Submissions Report

New Education Campus at 207 Barry Way,
Jindabyne

SSD-15788005- MOD – 1

On behalf of
NSW Department of Education
January 2023

Figure 1 – Tree Study Plan

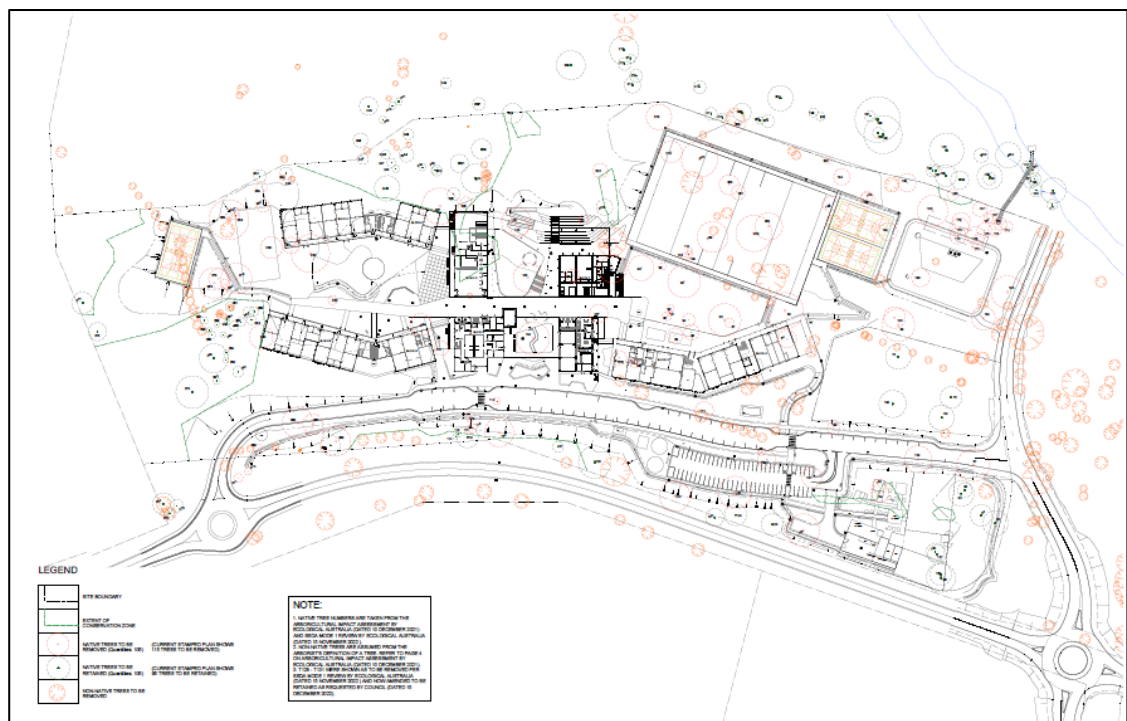
Design refinement	Reason			
Tree Retention	Following comments in Council's submission, the proposal has been modified to retain the 4 native trees within the paddock facing Barry Way.			
	A summary of the changes comparing the approved status and modification submission design refinement is provided below.			
	Tree No.	Approved Status	Mod Status	Reason
	62	Removed	Retained	<p>Reason for removal previously: Tree 62 was identified with a high retention value. This tree was considered important and identified to be prioritised for retention and protection. However, the tree was found to be subject to high impact and proposed to be removed.</p> <p>Reason for retention at MOD1: Following assessment of the proposed modification by Ecological Australia, it was found that the proposed road has been realigned to the south of the previous location and no longer resulted in a high impact to the tree.</p>

127	Retained	Removed	<p>Reason for retention previously: Tree 127 was identified with high retention value and subject to low impact during assessment of the SSD application.</p> <p>Reason for removal at MOD1: Following assessment of the proposed modification, it was found that impact into the TPZ/SRZ of tree due to the need for a truck turning head serving the Agriculture Plot.</p>
123	Retained	Removed	<p>Reason for retention previously: Tree 123 was assessed with a high retention value that would be subject to medium impact. Retention of T123 was identified to require further investigation and mitigation methods.</p> <p>Reason for removal at MOD1: Following assessment of the proposed modification by Ecological Australia, it was found that the tree would be subject to high impact as a result of a broader extent of road batter in this location.</p>	
122	Removed	Retained	<p>Reason for removal previously: Tree 122 was identified with high retention value and considered important and should be prioritised for retention and protection. However, this tree was found to be subject to high impact and proposed to be removed.</p> <p>Reason for retention at MOD1: Following assessment of the proposed modification, Ecological Australia</p>

Design refinement	Reason			
				found the amendment to the carpark and extent of road batter in this location will result in low impact.
	116	Removed	Retained	<p>Reason for removal previously: Tree 116 was identified with medium retention value but subject to high impact and proposed to be removed.</p> <p>Reason for retention at MOD1: Following assessment of the proposed modification, Ecological Australian identified that the extent of road batter had changes and the low impact would allow retention of the tree.</p>
	128	Retained	Retained	<p>Reason for removal previously as part of MOD1: Tree 128 was initially proposed under this modification to be removed due to construction methodology to accommodate site entry and site accommodation.</p> <p>Reason for retention at MOD1: The construction methodology has now been amended to relocate site entry and site accommodation, thus reducing the impact to tree 128 so the tree can be retained. The details of the construction methodology are to be provided in accordance with Condition B15 of SSD-15788005 as part of the Construction Environmental Management Plan</p>

129	Retained	Retained	<p>Reason for removal previously as part of MOD1: Tree 129 was initially proposed under this modification to be removed due to construction methodology to accommodate site entry and site accommodation.</p> <p>Reason for retention at MOD1: The construction methodology has now been amended to relocate site entry and site accommodation, thus reducing the impact to tree 129 so the tree can be retained. The details of the construction methodology are to be provided in accordance with Condition B15 of SSD-15788005 as part of the Construction Environmental Management Plan</p>
	130	Retained	Retained	<p>Reason for removal previously as part of MOD1: Tree 130 was initially proposed under this modification to be removed due to construction methodology to accommodate site entry and site accommodation.</p> <p>Reason for retention at MOD1: The construction methodology has now been amended to relocate site entry and site accommodation, thus reducing the impact to tree 130 so the tree can be retained. The details of the</p>

Design refinement	Reason		
			<p>construction methodology are to be provided in accordance with Condition B15 of SSD-15788005 development consent as part of the Construction Environmental Management Plan.</p>
131	Retained	Retained	<p>Reason for removal previously as part of MOD1: Tree 131 was initially proposed under this modification to be removed due to construction methodology to accommodate site entry and site accommodation.</p> <p>Reason for retention at MOD1: The construction methodology has now been amended to relocate site entry and site accommodation, thus reducing the impact to tree 131 so the tree can be retained. The details of the construction methodology are to be provided in accordance with Condition B15 of SSD-15788005 development consent as part of the Construction Environmental Management Plan.</p>

The original approved MOD1 submission noted 109 trees to be removed and 101 trees to be retained. The latest plan notes 105 trees to be removed and 105 trees to be retained (4 additional trees to be retained at the request of the Snowy Monaro Regional Council). Further, the current landscape plan shows an additional 172 new trees to be planted as part of the project.

Appendix 3 – Pre-Development Catchment Plan

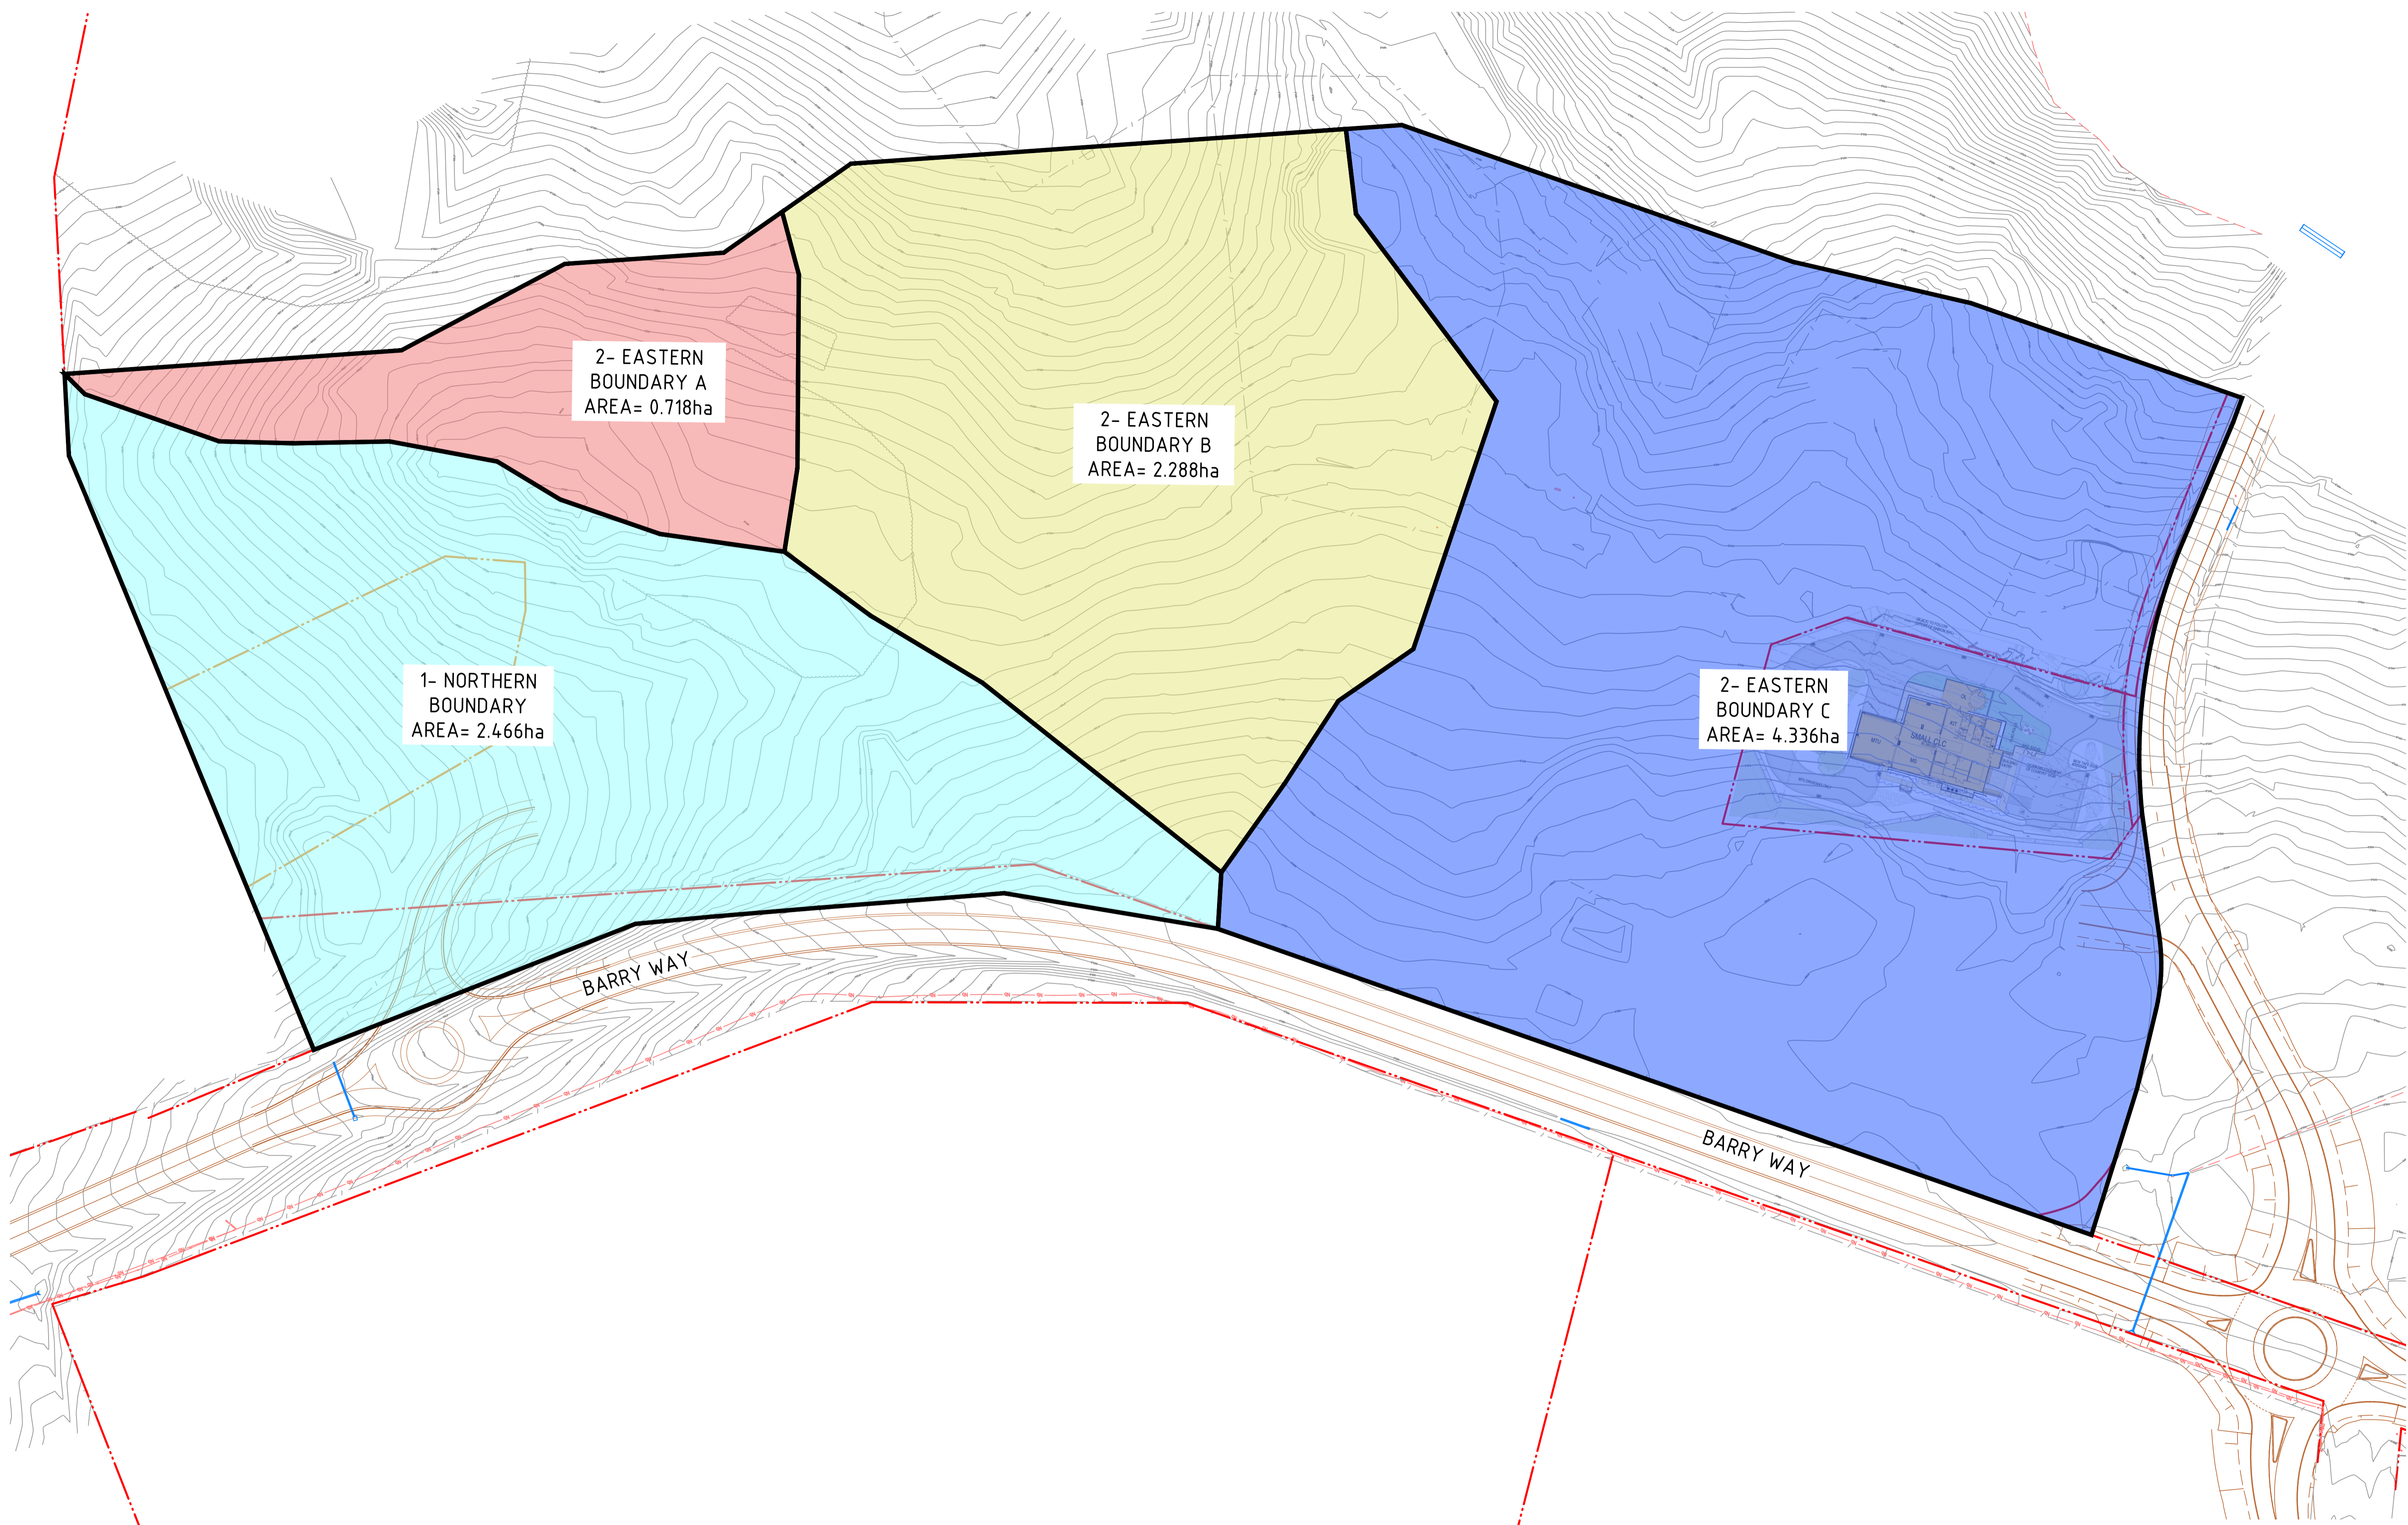
Summary of issue/comment	Response
<p><i>Council has no objections to changes to storm water management if the principles of post development flow not exceeding predevelopment flow are followed. Any design must ensure that stormwater is not directed onto neighbouring properties without appropriate easements and infrastructure in place.</i></p>	<p>The same principles for the stormwater have been applied as per the approved documentation whereby we meet the pre to post development flows and we are not discharging onto adjoining private property requiring easements or the like.</p> <p>In addition to this we have provided the pre and post development catchment plans in Appendix 3 and Appendix 4 respectively. Drawing 0603 provides a table indicating the pre and post development flows for all storm events from 20% AEP to 1% AEP highlighting reduced flows for all events.</p>

In response to Snowy Monaro Regional Council comments, the proposal now proposes to retain the 4 native tree facing Barry Way, the retention of these tree will also address the concern raised with providing suitable screening to the agricultural building and shade for the livestock as this is consistent with the rural character of the area. The concern raised with regards to the external roundabout configuration can be adequately addressed through existing conditions of consent. In terms of stormwater management, pre and post development catchment plans have been provided that demonstrate the reduced flows for all storm events.
